OLD ORCHARD BEACH  
PLANNING BOARD  
January 2018 MEMO

# January 2018 Planning Board Memo: Table of Contents

ITEM 2: <b>Site Plan:</b> 87 West Grand .....	<b>PAGE 2</b>
ITEM 3: <b>Private Way:</b> Portland Ave .....	<b>PAGE 4</b>
ITEM 4: <b>Subdivision Amendment:</b> Sandy Meadows .....	<b>PAGE 13</b>
ITEM 5: <b>Subdivision Amendment:</b> 8 Lot Subdivision .....	<b>PAGE 17</b>
ITEM 6: <b>Subdivision Amendment:</b> Deshaies Ross Road .....	<b>PAGE 18</b>
ITEM 7: <b>Private Way:</b> Deshaies Ross Road .....	<b>PAGE 19</b>
ITEM 8: <b>Site Plan Review:</b> 19 Heath Street.....	<b>PAGE 26</b>
ITEM 9: <b>Shoreland Zoning:</b> 18 Tioga.....	<b>PAGE 29</b>

**ROSS ROAD PRIVATE WAY**

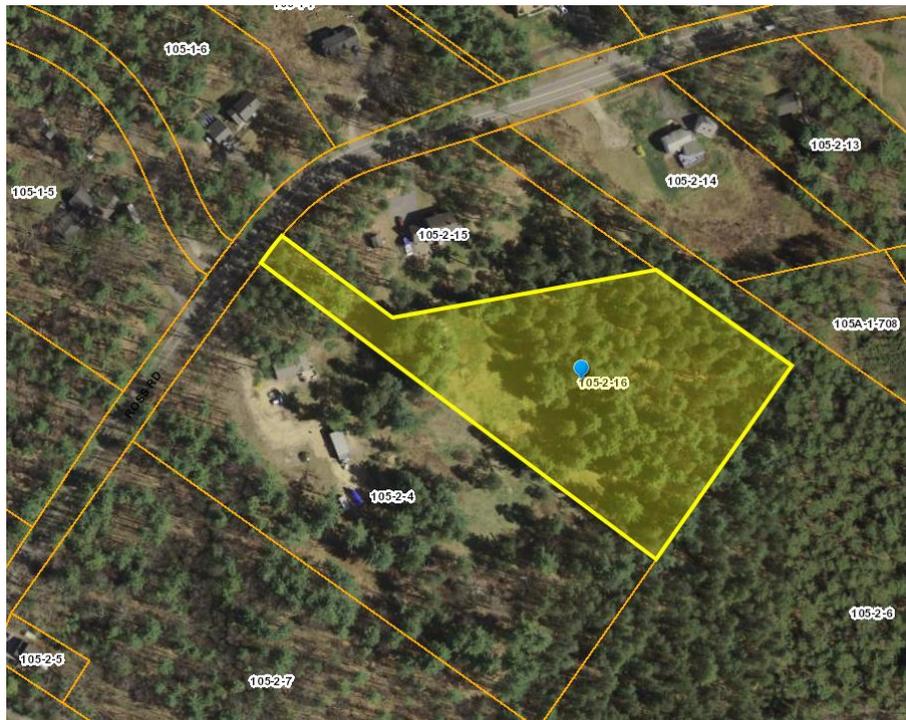
1. The private way plan does not include any boundary related information (metes/bounds) to define the ROW. This would be recommended to establish the exact location and direction of the ROW. Based on taped measurements, the ROW appears to meet the 50-foot width required by the Town ordinance.

2. A "Private Way Note" is included on the plan noting the private way is to be maintained by the abutters. We would recommend clarifying the term abutter, as the roadway appears to abut two existing residential units (Lot 1 and Lot 2) which appear to be existing lots with access off Ross Road.

3. Typical Roadway Section: Sec 78-1414(b) – Construction Standards requires a roadway subbase to be a minimum 15-inches. A revised plan submitted on 1/2/18 modified the gravel depth, however the rev 2 plan (submitted via email on 1/3/18) references a 12-inch subbase gravel depth.

4. Compliance with Construction Standards: Inspection and Certification (Sec 78-1414(d)). Town/owner may want to consider adding a note to the plan for reference.

5. Review and confirmation of adequate sight distance from the Private Way is recommended. The plans reference a sight distance to the north of 250-feet. As part of my review, I was unable to determine the speed limit along this portion of Ross Road, which will aid in determining the minimum sight distance requirements.

7. The Towns Private Way application requests “Drainage Calculations and Stormwater Management plan” requirements. Drainage calculations were not included in the application package provided. An erosion and sedimentation control plan was submitted.

- a. It is recommended invert and outlet locations be referenced on the plan view to confirm proposed direction of culvert flow and what is considered the upgradient ditch line.
- b. We would recommend additional details and information be provided denoting how the discharge of water from the roadway and ditch lines will flow and whether the development of the roadway will increase stormwater volumes offsite. The culvert/low point in the roadway appears to discharge to the property line of developed Lot 1. Based on the topography noted on the plans, this area appears to be relatively flat.

9. The southern side of the roadway does not show a ditch line in plan view and appear to tie in with existing grades. The typical roadway section detail references a defined ditch line, which may or may not be applicable. If the applicant is proposing a ditch line for conveyance of runoff, driveway culverts may be applicable.

*This information was added to the most recent Private Way plan submitted by the Applicant that Planning Staff has copies of.*

*Wright Pierce pointed out a good point that the term "abutters" could be misconstrued in this instance as there are two "abutting lots" to this proposed lot split. However, it is required by ordinance to list either Abutters or Developer and to include this note on the plan. While this private way is only intended to serve two lots and does not by itself trigger subdivision review, it is considered part of a larger subdivision which triggers the need for this note. Planning Staff is leaving the decision up to the PB as to whether or not the board would like this to continue to say Abutters or if the board would like it to be changed to say "lot owners" or something that is clearer but is not necessarily spelled out in the ordinance."*

*Planning Staff noticed on the original Private Way plan that the subbase depth was only 12 inches instead of the minimum requirement of 15 inches. Staff asked for the Applicant to update the plan, when the Applicant sent the updated plan, the topo was turned off, we asked for that layer to be turned back on and when it was it reverted back to the old plan by mistake. This has been added to the most recent Private Way plan submitted by the Applicant that Planning Staff has copies of.*

*This information was added to the most recent Private Way plan submitted by the Applicant that Planning Staff has copies of.*

*Under the construction standards section of our ordinance, it says that a Private Way serving 3 or more dwelling units “must comply with requirements of the town subdivision review standards in chapter 74.” We suspect the reason the Private Way application requests “drainage calculations and stormwater management plan” is to cover the private ways that intend to serve 3 or more lots, not 2 lots. Planning Staff does not feel that drainage calculations are required for a private way serving 2 lots. The stormwater requirements for a private way serving two lots say “approval of director of public works.” Staff recommended to the Applicant that they take a look at the Towns stormwater ordinance, Chapter 71. Chapter 71 references MDEPs Chapter 500 which requires an Erosion and Sedimentation Control plan which has been submitted.*

*This information was added to the most recent Private Way plan submitted by the Applicant that Planning Staff has copies of, flow direction arrows have also been shown on the updated plan. Drainage calculations have not been provided because the Applicant received approval for the stormwater implications of this development by the Public Works Director.*

*This information was added to the most recent Private Way plan submitted by the Applicant that Planning Staff has copies of. The ditch is no longer on the plan for the southern side of the road.*
